ADDENDUM NO. 05

PROJECT: South Orangetown Central School District
PHASE 2: 2022 BOND

CPL PROJECT NO. 14457.20

DATE: November 19, 2024

1 BOILER ROOM HVAC PIPING NEW WORK PLAN
1/4" = 1'-0"

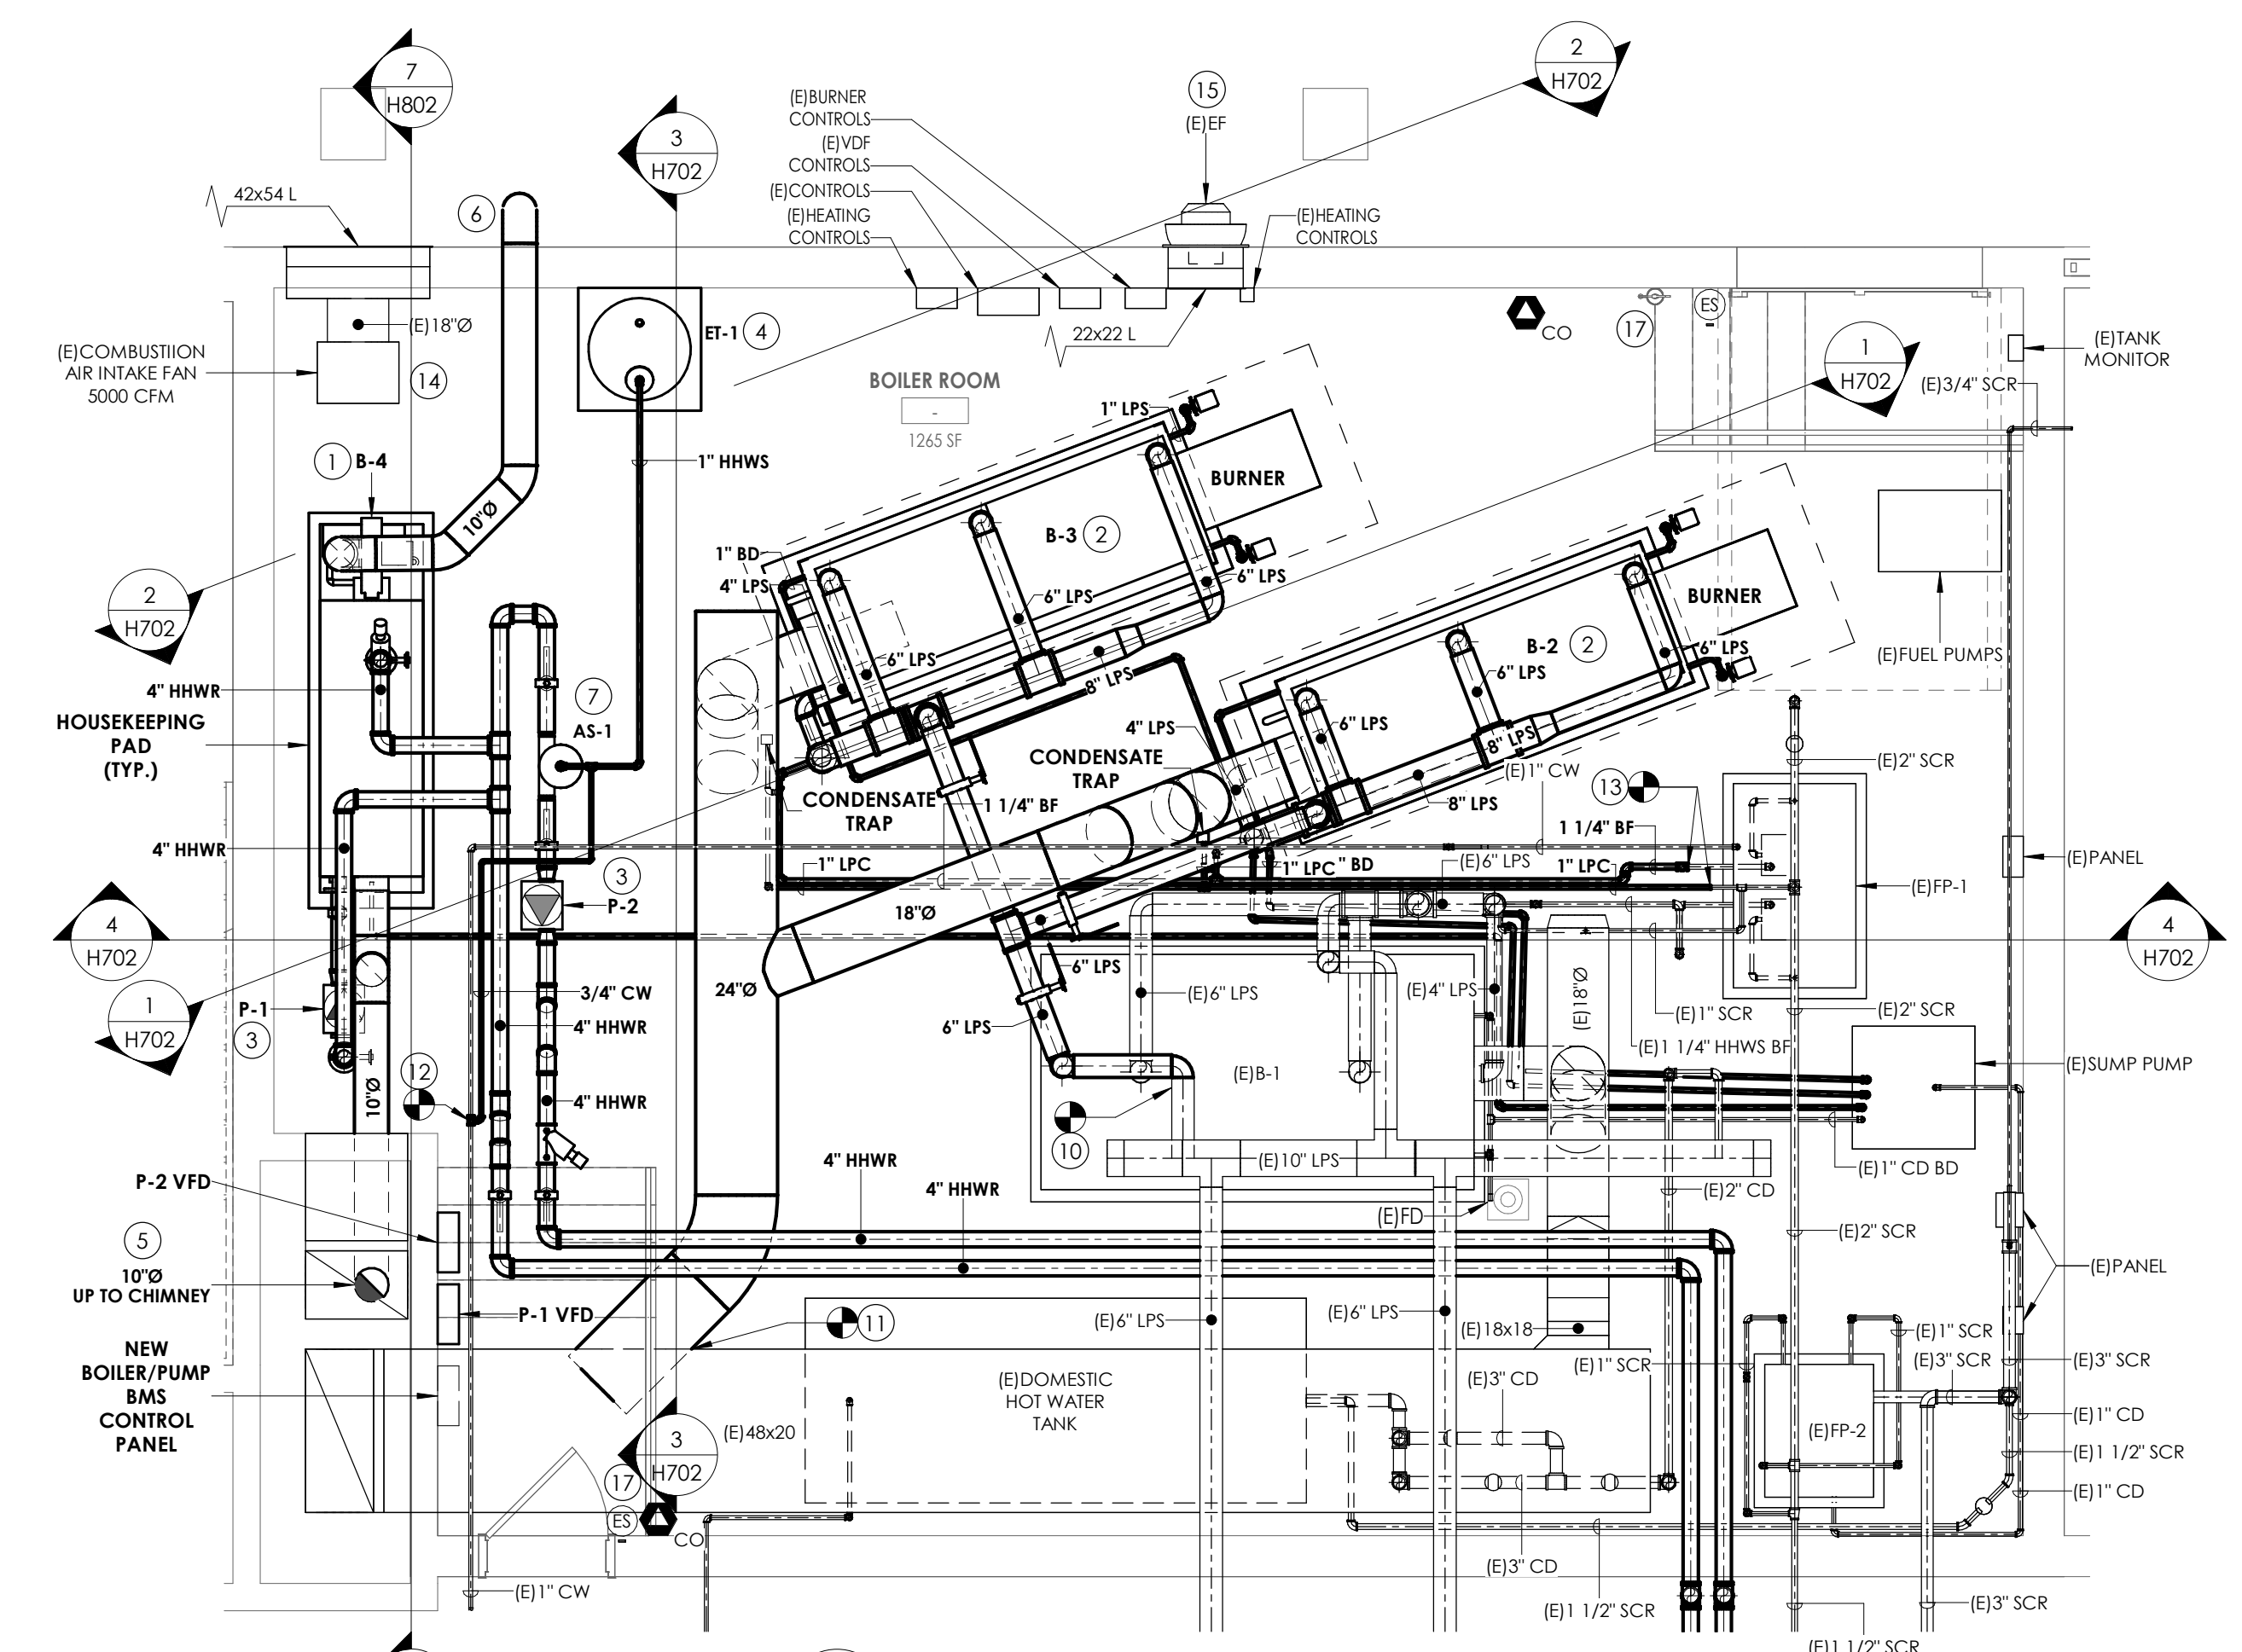
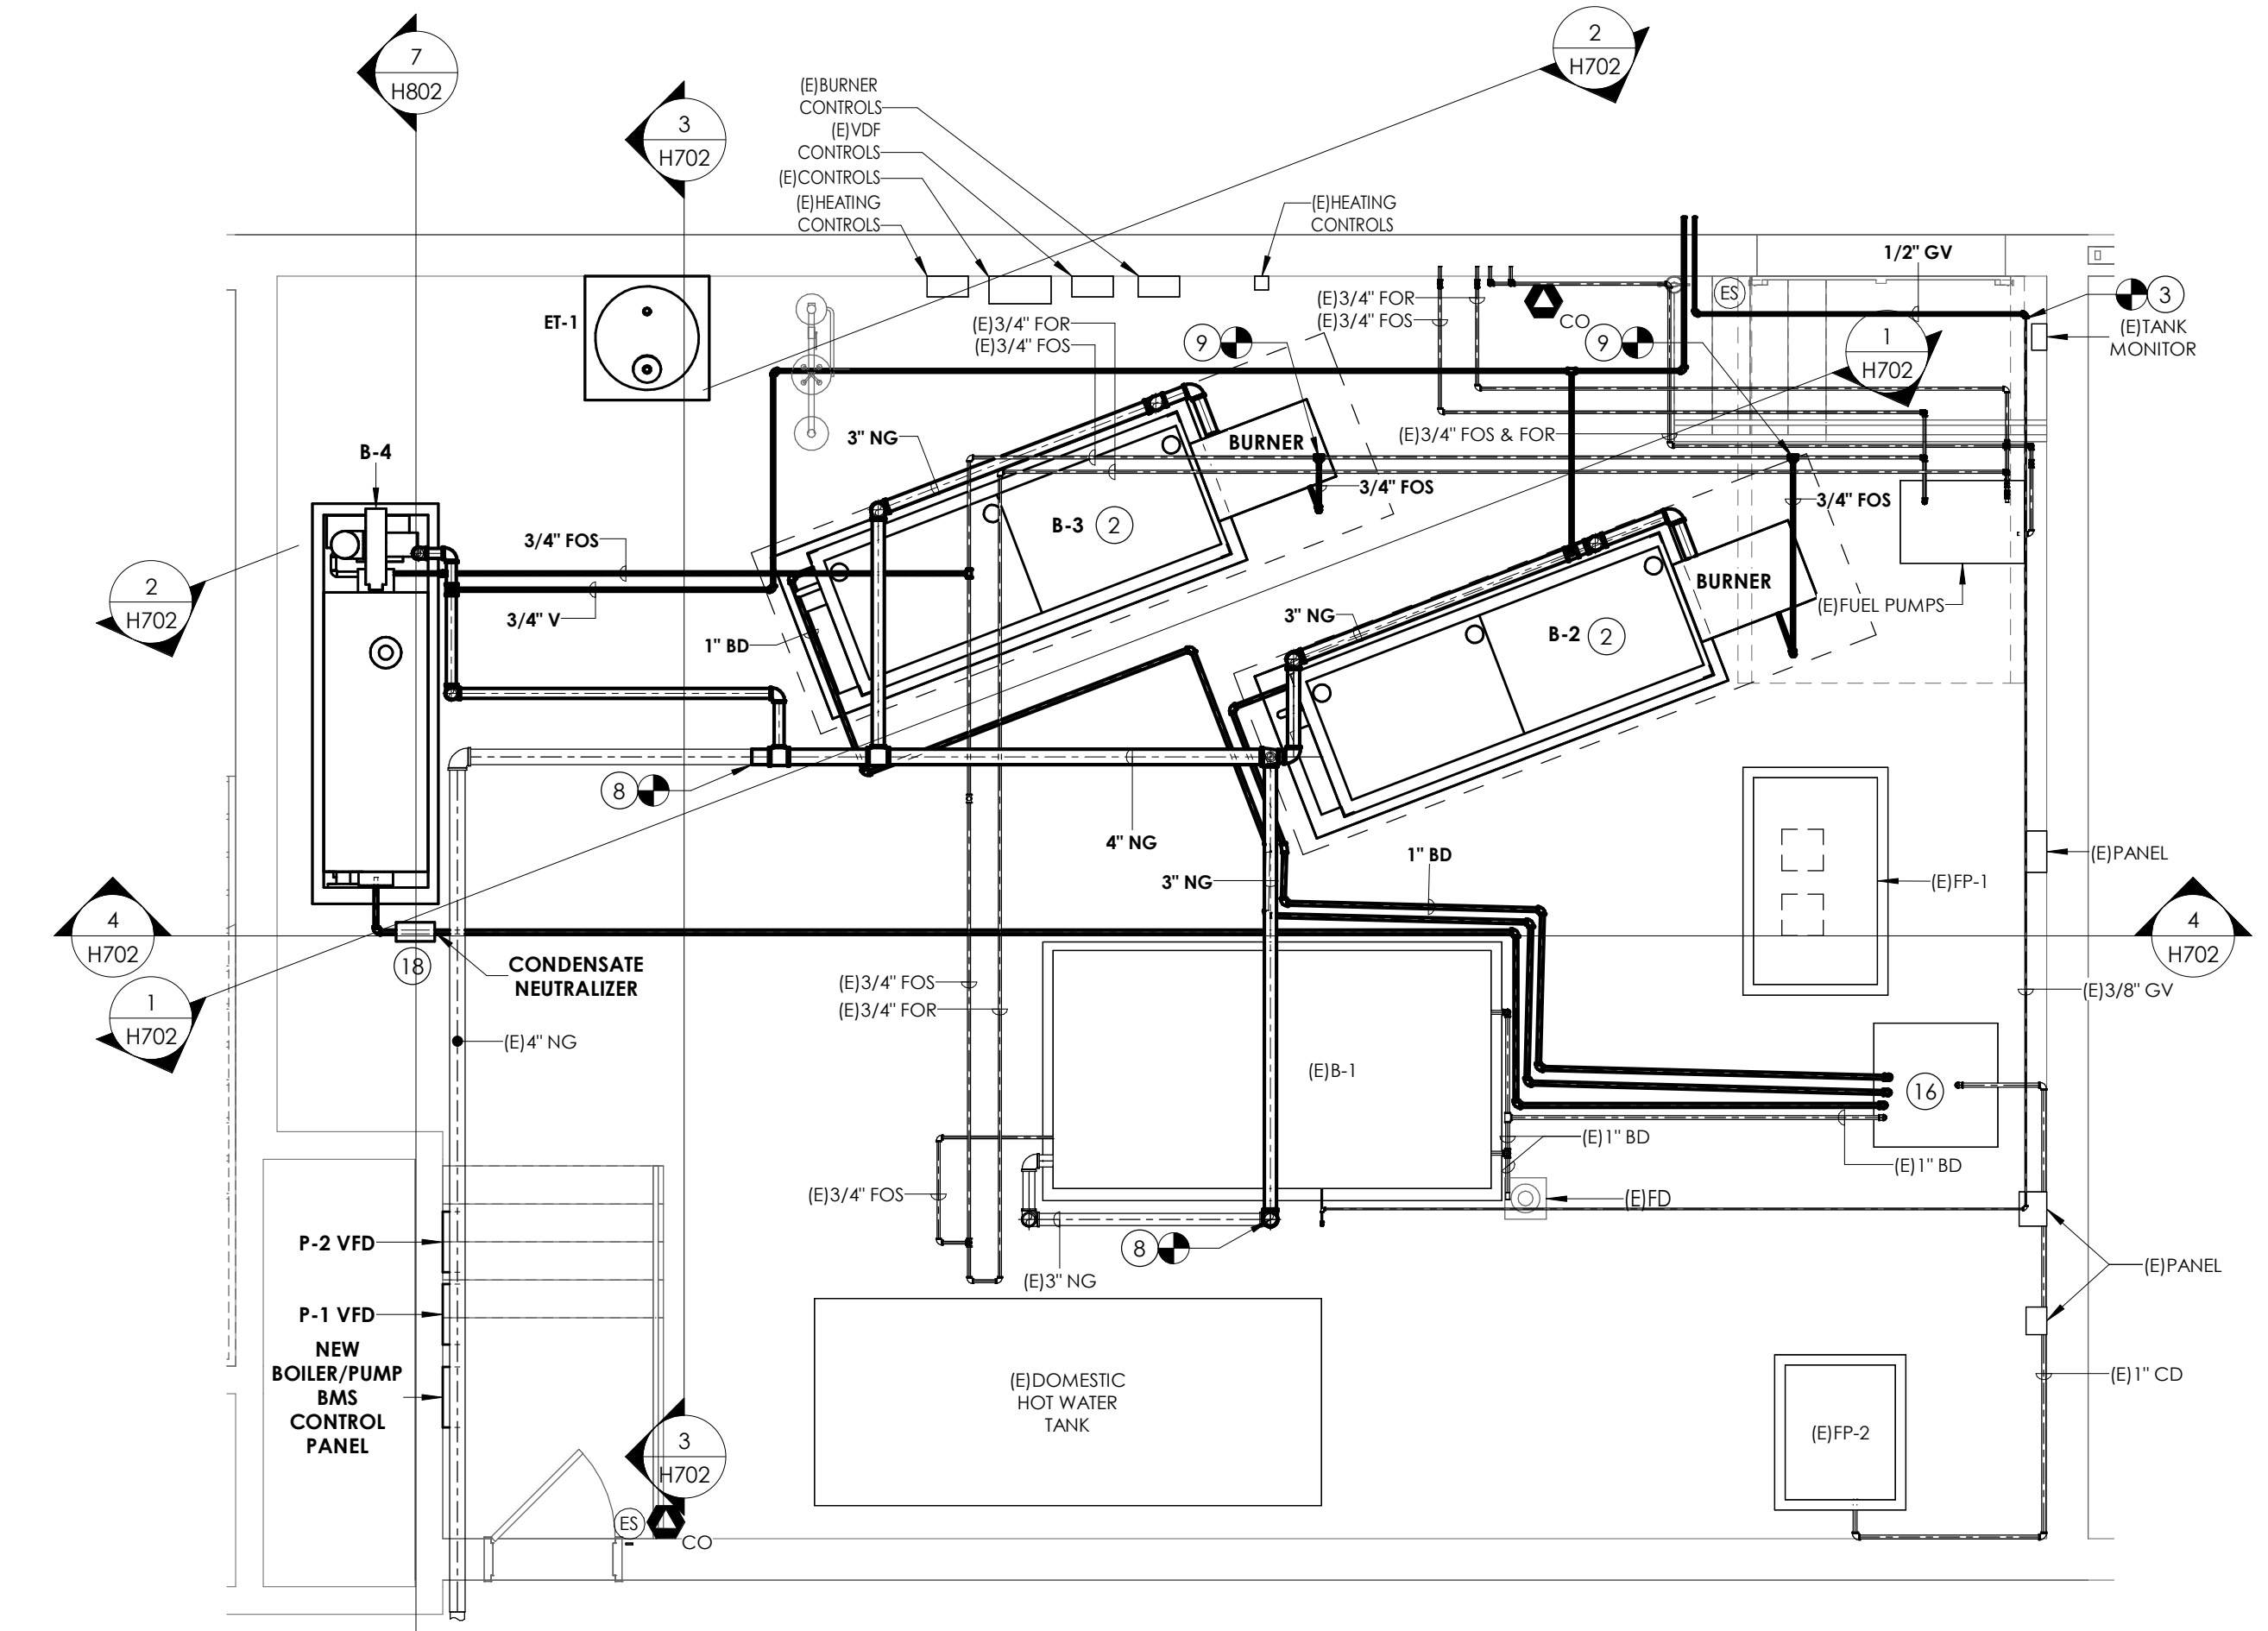
- 3.20 Drawing H303: Replace with attached revised H303.
- 3.21 Drawing H700: REVISE KEYNOTE 2 as follows:
REMOVE BOILER, FLUE, BLOW DRAIN PIPING, GAS VENT PIPING AND CONTROLS. GC TO REMOVE HOUSEKEEPING PAD.
